In the Matter of:) Docket No. 09-IEP-1
)
Preparation of the) COMMENT ON CALIFORNIA ENERGY DEMAND
2010-2020 STAFF DRAFT FORECAST
2009 Integrated Energy Policy Report)
(2009 IEPR))
)
)
_____)

**Comments of the California Public Utilities Commission's Energy Division
on the *California Energy Demand 2010-2020 Staff Draft Forecast***

Figure 2. Total solar installed capacity in California: 1981-2009 (Source: *California Solar Initiative Annual Program Assessment*).¹⁰

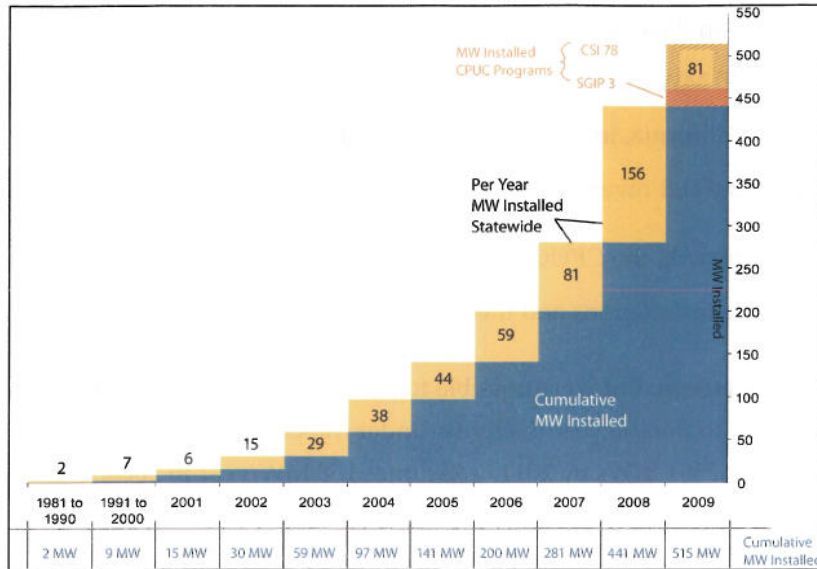
- (1) The Draft Forecast methodology uses average per annum installations for 2007 and 2008, whereas in California, the IOUs have averaged 30-40% growth since 1981, with an approximately 100% growth rate between 2007 and 2008 installations. (See Figure 2 and Table 1 below.) The annual growth rate has been positive every year for over a decade – there has never been a year that installed fewer MWs than the year before.

- b. **Medium Scenario.** If the annual growth rate in new installed solar capacity continued to grow at just 50 percent per year (which is closer to the per annum growth rate over the past decade, as shown in Figure 2 above), then the CSI Program would install ~1,750 MW by the end of 2012. (This assumes 158 MW/year in 2008, and ~230 MW/year in 2009, etc.)

The Draft Forecast methodology projected installation rates for CSI and other self-generation programs is inconsistent. Currently, New Solar Homes Partnership (NSHP) pending and installed projects information is used, while, for CSI, only a “historic average” of 2007 and 2008 installation rates is used. We urge the Energy Commission to apply the same “reasonably expected to occur” (RETO) standard to all DG resources (whether CSI, SGIP, NSHP, or other). Energy Division staff is prepared to assist Energy Commission staff to reconcile these variations in the RETO standards for DG. In addition, the following are key points to consider when revising programmatic self-generation assumptions:

Figure 3. Estimated CSI Impact on CAISO 2008 System Peak (Source: *Preliminary Program Impacts Results Report*, June 2009.)¹³

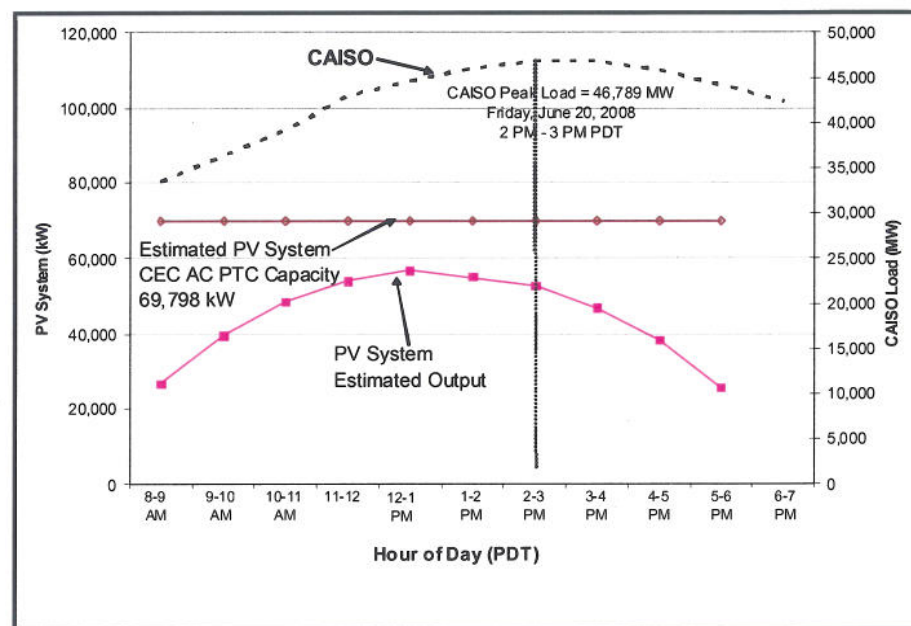
- (1) Metered performance data is becoming available through SGIP and CSI Program Evaluations that could be used to update the coincident-peak output assumptions. While CSI and SGIP PV peak output do not directly match the California ISO peak, there is still an increasing availability of PV capacity during peak periods.¹² (See Figure 3 and Tables 2 and 3 below.)
- (2) The SGIP has conducted multiple impact evaluations, and in June 2009, the CPUC received Itron's Eighth Year Impact Evaluation. The Draft Forecast cites the fourth year impact evaluation from 2005. We recommend the Revised Forecast be updated with the additional 4 years of more recent data from these reports, such as the 2009 study which includes California ISO peak performance figures for different types of self-generation in 2008 and prior, including different values for solar, CHP, fuel cells, and wind turbines.
